Notice of Proposed Amendment 2017-04

Regular update of aerodrome rules

CS-ADR-DSN — Issue 4

RMT.0591

Figure L-10C. Mandatory instruction marking inscription form and proportions

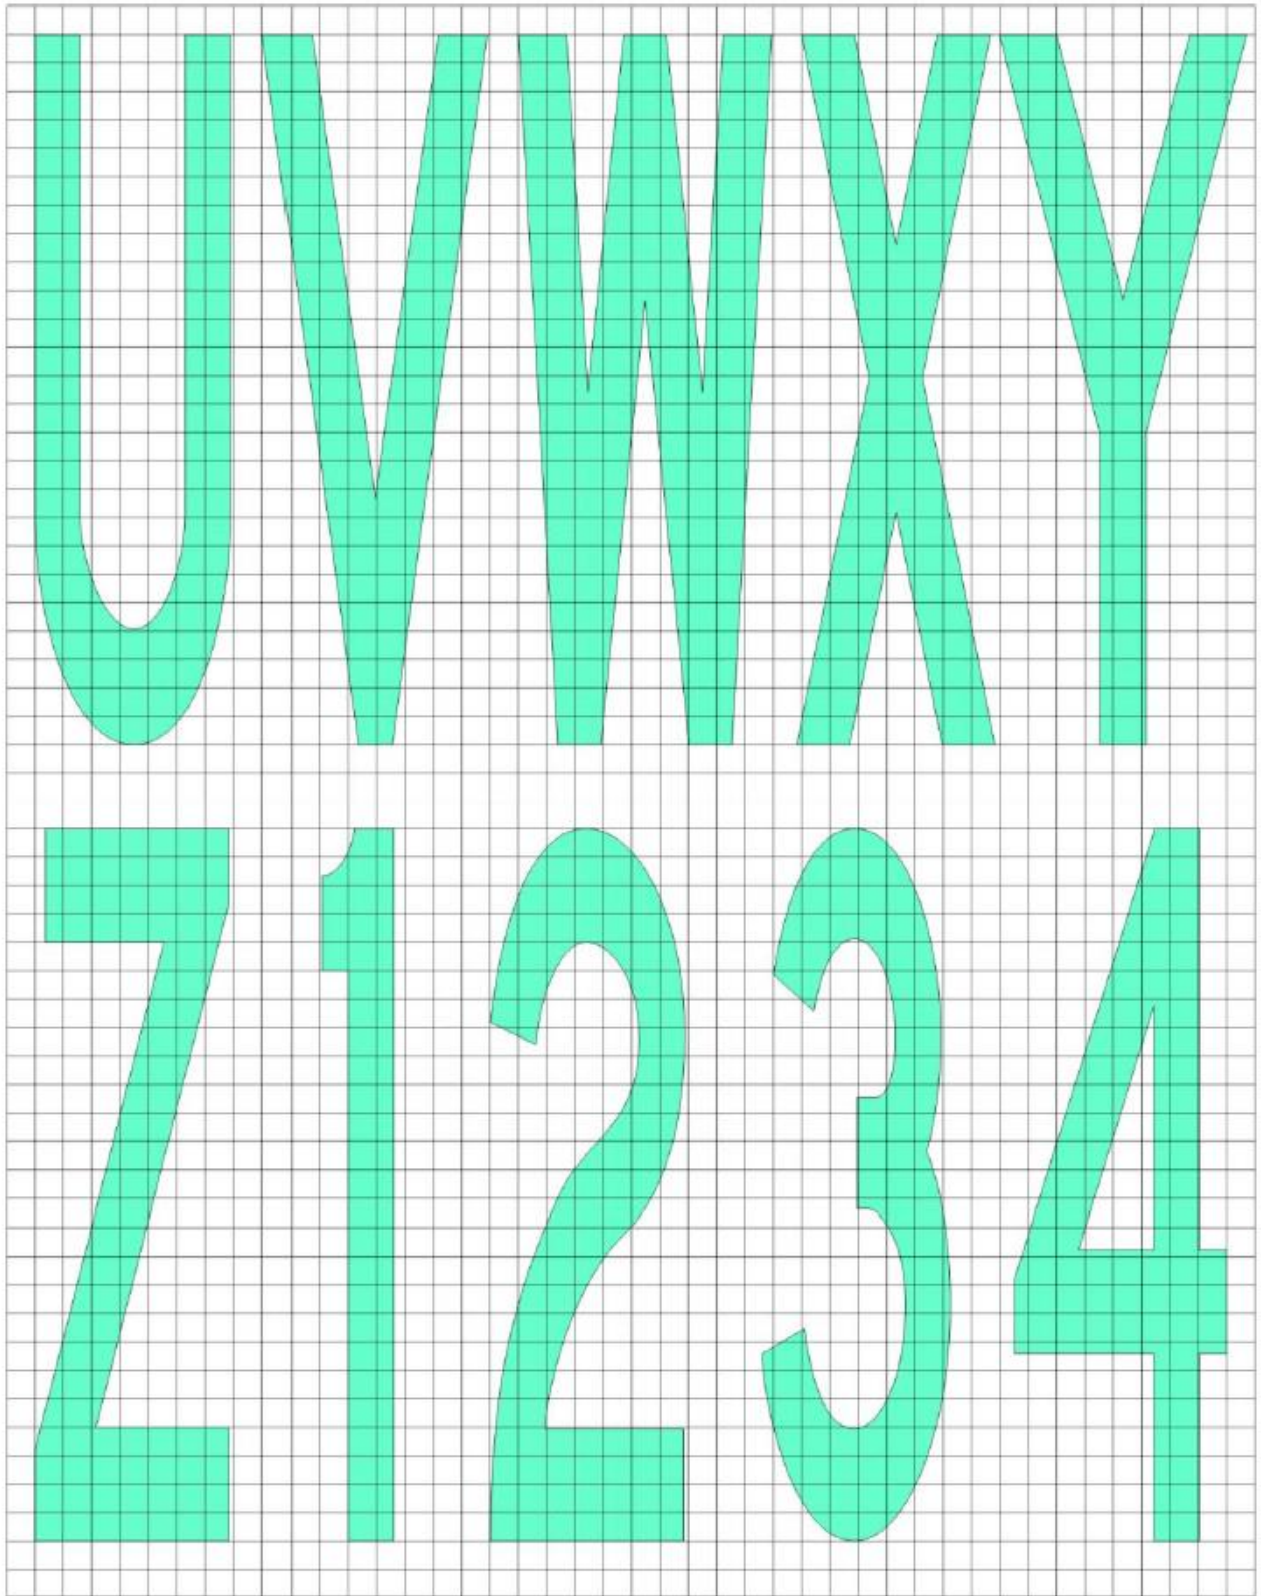
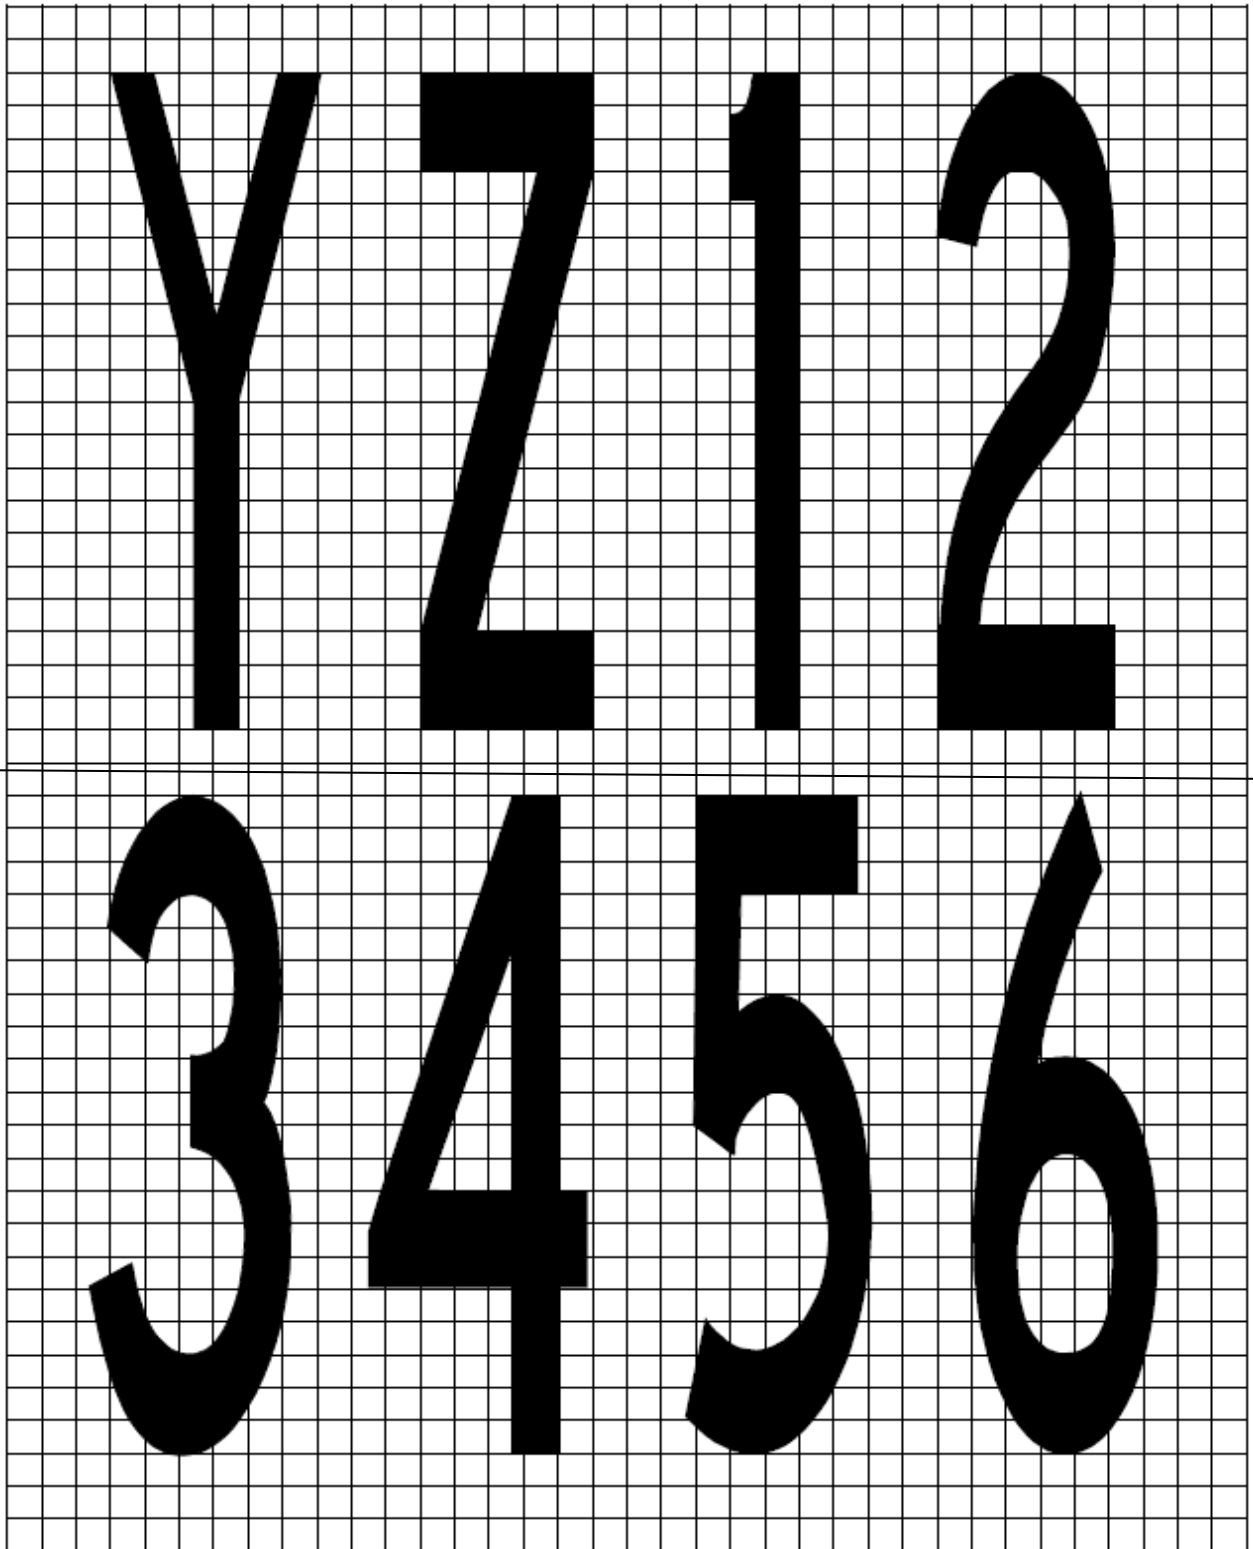
[Editorial note: Figure L-10C is deleted:]

[Editorial note: new Figure L-10C is added as follows:]

Figure L-10D. Mandatory instruction marking inscription form and proportions

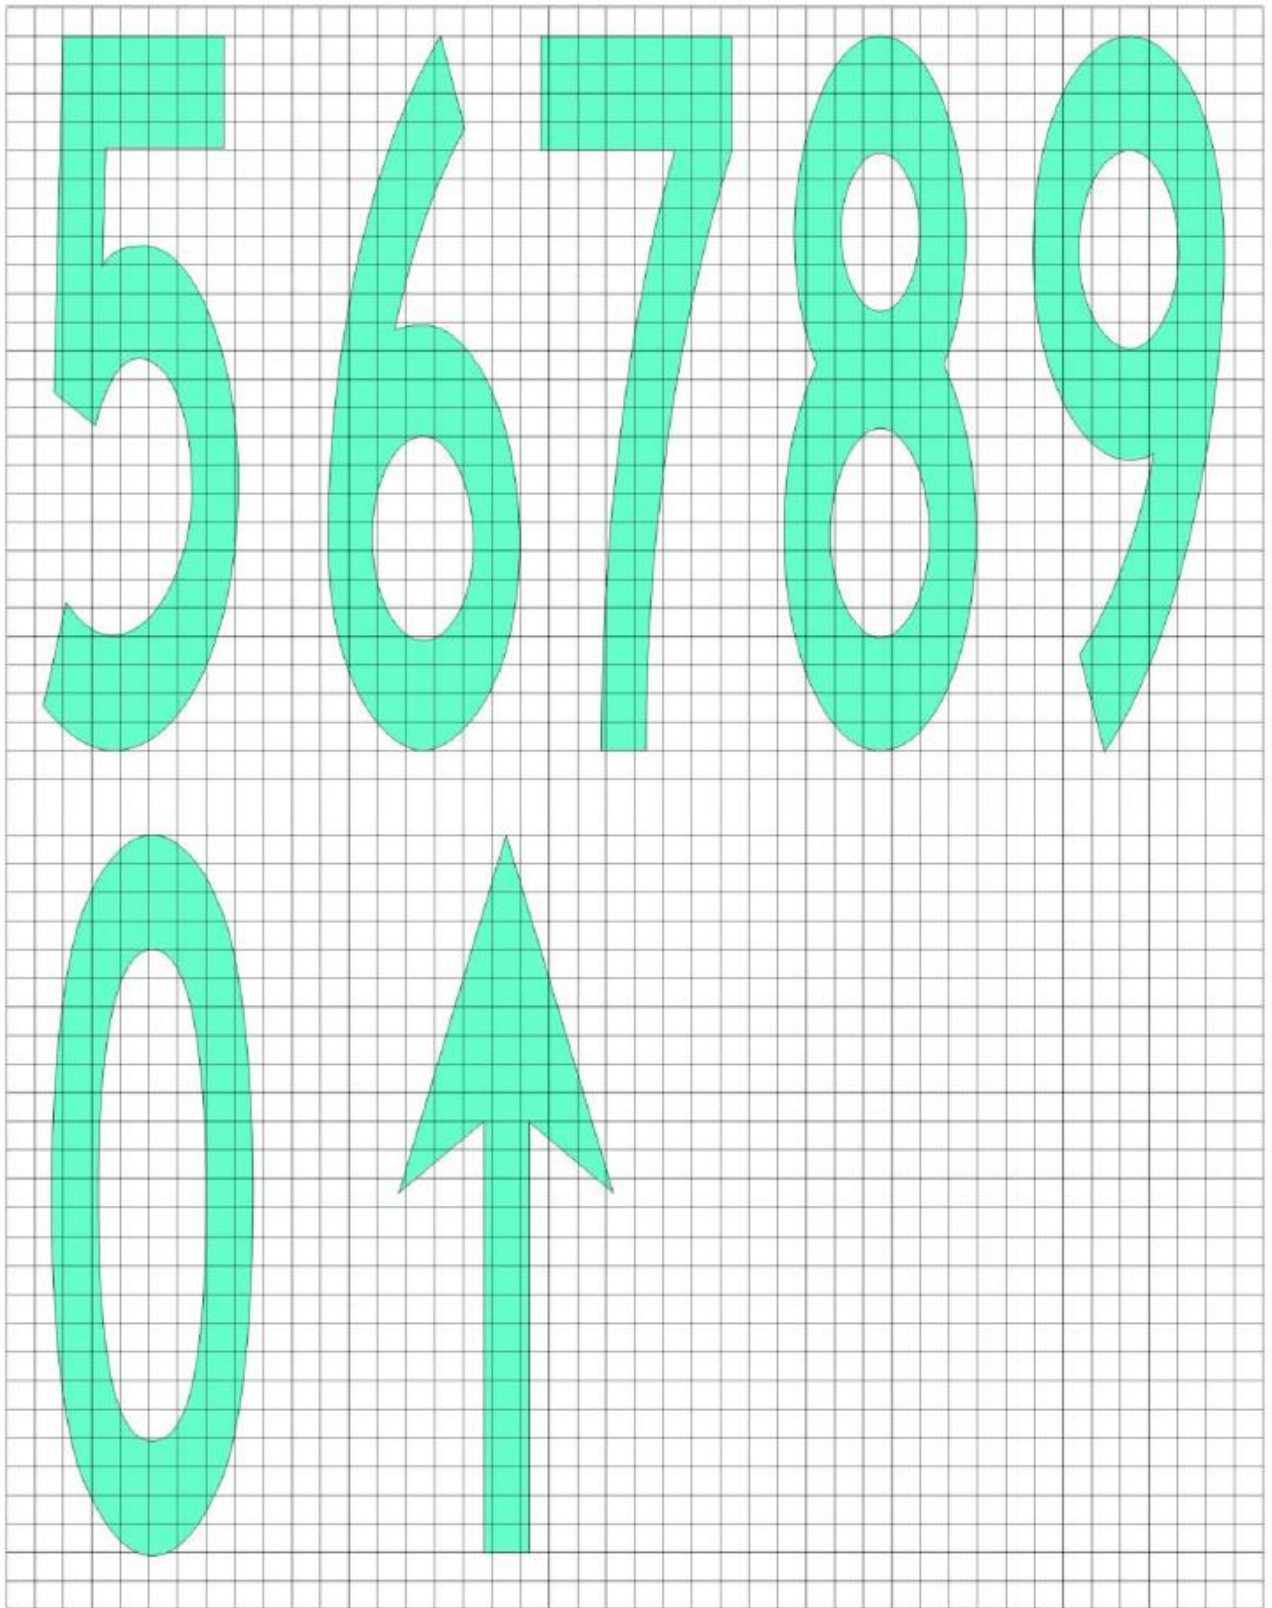
[Editorial note: Figure L-10D is deleted:]

[Editorial note: new Figure L-10D is added as follows:]

Figure M-6. Obstacle protection surface for visual approach slope indicator systems

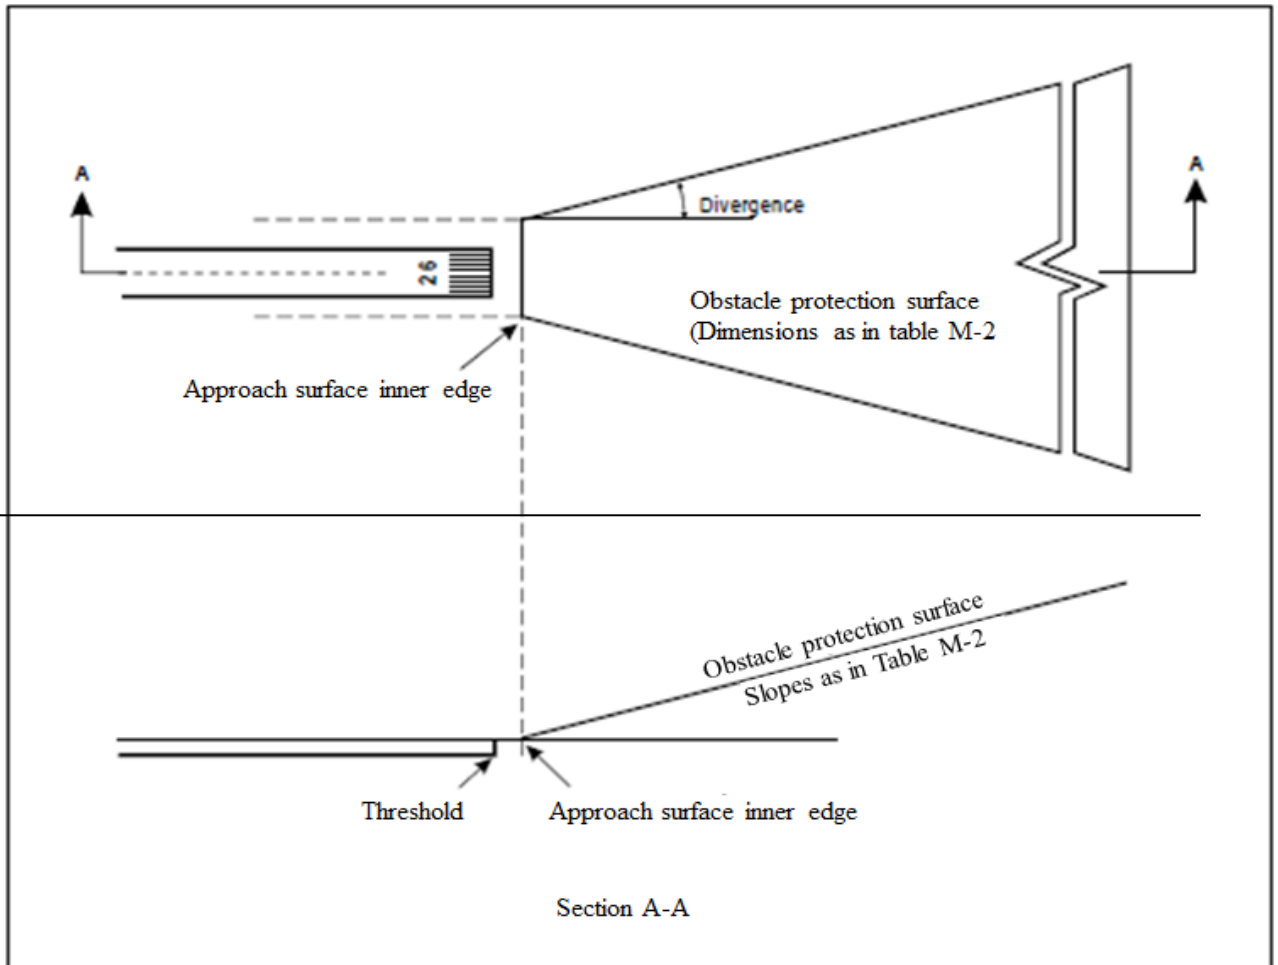
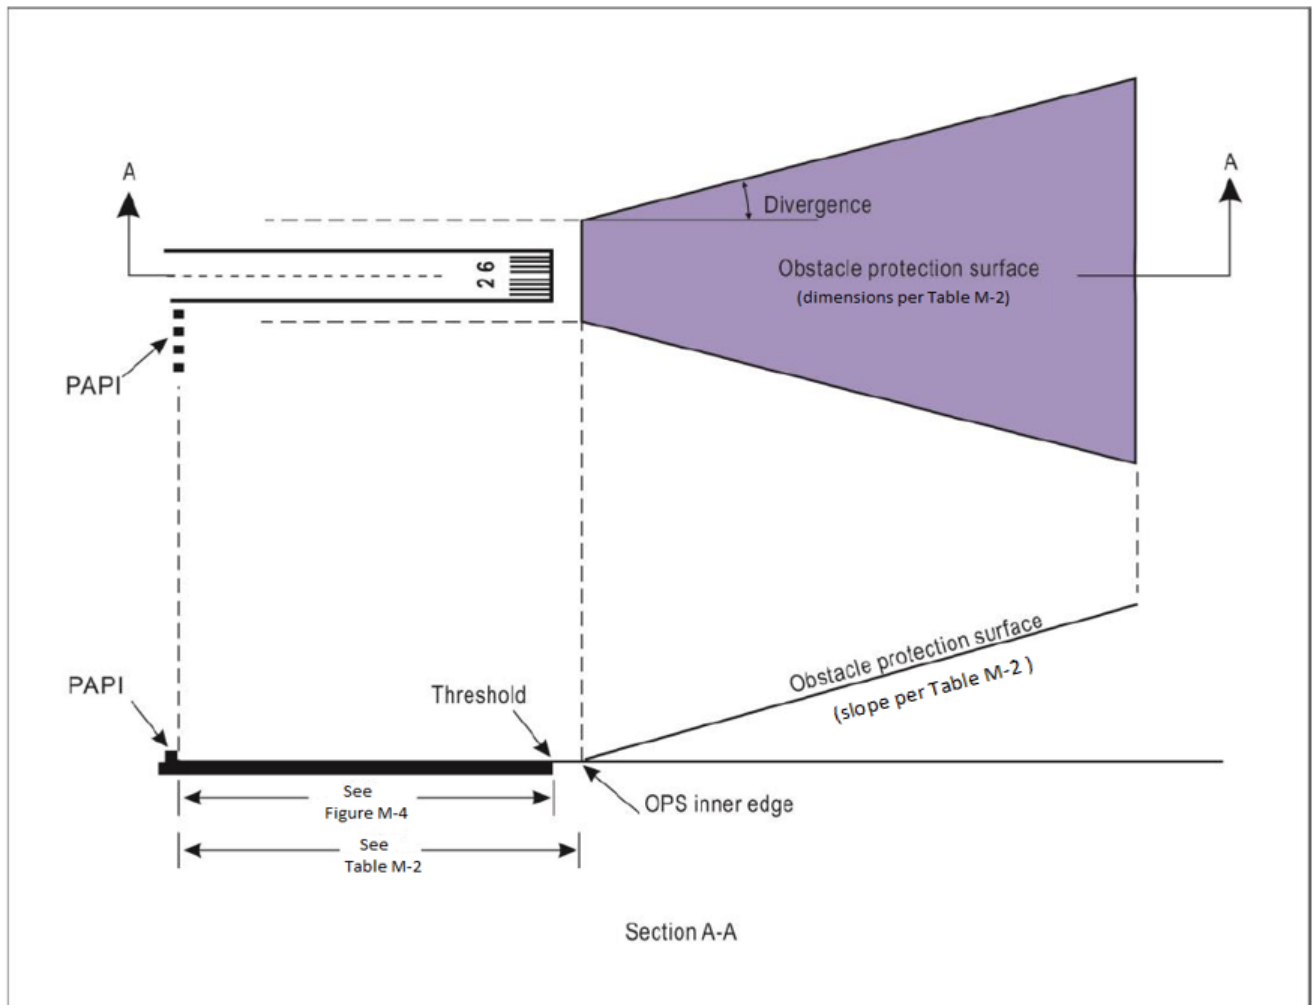
CS ADR-DSN.M.655(d), Table M-2 and Figure M-6 have been amended in accordance with ICAO Annex 14, 'Aerodromes', Volume I, Amendment 13-A, keeping the possibility of displacing the threshold, which was agreed at the thematic meeting on visual aids.

[Editorial note: Figure M-6 is deleted:]

Editorial note: new Figure M-6 is added as follows:]

Figure N-2F- Runway vacated sign with typical location sign

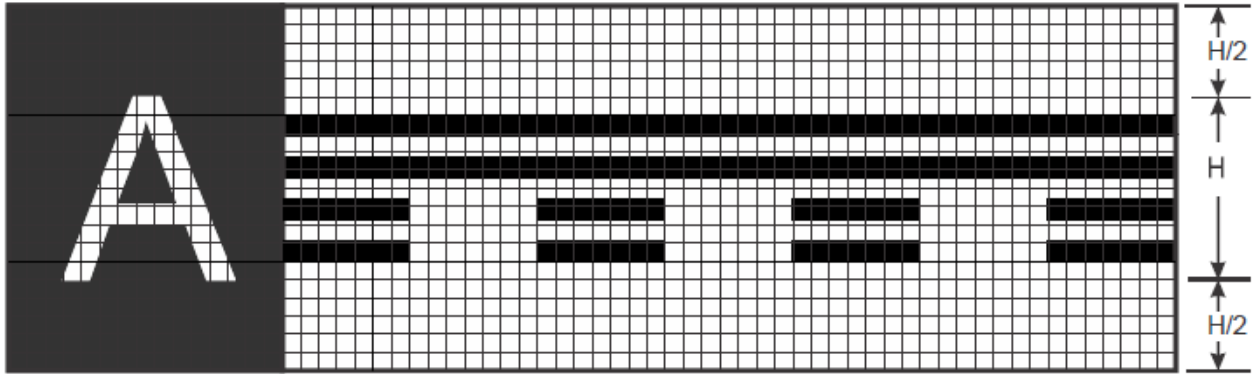
The title of Figure N-2F has been updated.

[Editorial note: Figure N-2F is deleted:]

[Editorial note: new Figure N-2F is added as follows:]

Figure N-2G. No entry sign

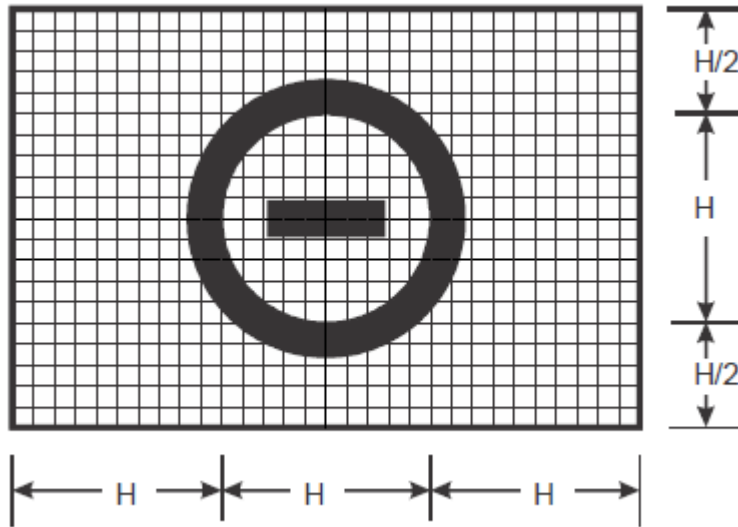
A new design of Figure F-2G — No entry sign has been added.

[Editorial note: Figure N-2G is deleted:]

[Editorial note: new Figure N-2G is added as follows:]
